Access Compliance Report

# Public Rights-of-Way
(Curb Ramps)

Intersection ID: 50597	Main Street: DOWNY_BIRCH_RD	Cross Street: GRAY_WILLOW_RD	Location:	NE
ADA ID: 8B9A879E7C63	Ramp Type: Perp	Initial Pass/Fail: Pass	Overall Compliance: No	Severity Score: 0

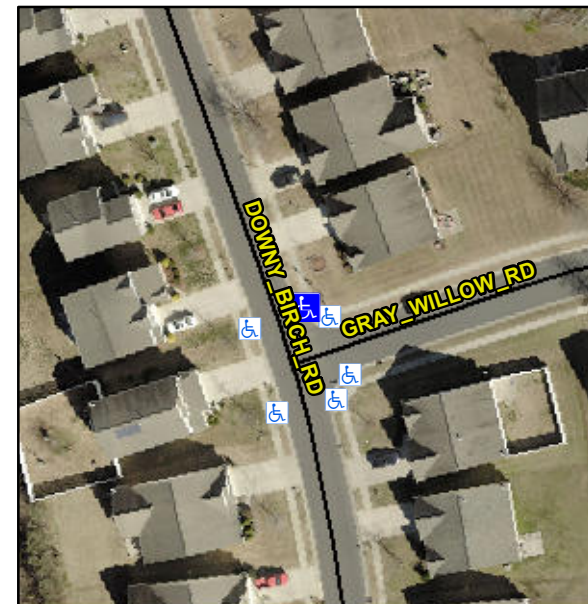
Not Found, R304.2.1, R304.2.2-Perp, R304.3.2-Para, R305.2

Compliance	Description	Data	Compliance	Description	Data
N/A	Ramp Length (in)	48.0	Yes	Ramp Slope (%)	6.7
Yes	Ramp Width (in)	48.0	Yes	Ramp XSlope (%)	1.2
N/A	Flare Type LT	Sloped	N/A	Flare Type RT	N/A
N/A	Flare Slope LT (%)	3.8	N/A	Flare Slope RT (%)	6.9
N/A	Flare Traversable LT?	No	N/A	Flare Traversable RT?	No
No	Landing Length (in)	47.5	Yes	DWS Provided?	Yes
Yes	Landing Width (in)	68.0	Yes	DWS Contrast?	Yes
No	Landing Slope (%)	2.9	Yes	DWS Length (in)	24.0
Yes	Landing X Slope (%)	1.6	Yes	DWS Full Width?	Yes
N/A	Landing Curb? (Y/N)	No	No	DWS Offset (in)	5.5
N/A	Shared Landing?	Yes			
Yes	Gutter Ponding?	No	Yes	Gutter Slope (%)	3.6
Yes	Gutter Lip Ht (in)	0.0	Yes	Gutter X Slope (%)	1.4
N/A	Painted X Walk1?	No	N/A	Painted X Walk2?	N/A
	X Walk 1 Direction	To W		X Walk 2 Direction	N/A
N/A	X Walk 1 Width (in)	N/A	N/A	X Walk 2 Width (in)	N/A
	X Walk 1 Slope (%)	3.2		X Walk 2 Slope (%)	N/A
	X Walk 1 X Slope (%)	0.8		X Walk 2 X Slope (%)	N/A

Remove & Replace Entire Ramp.
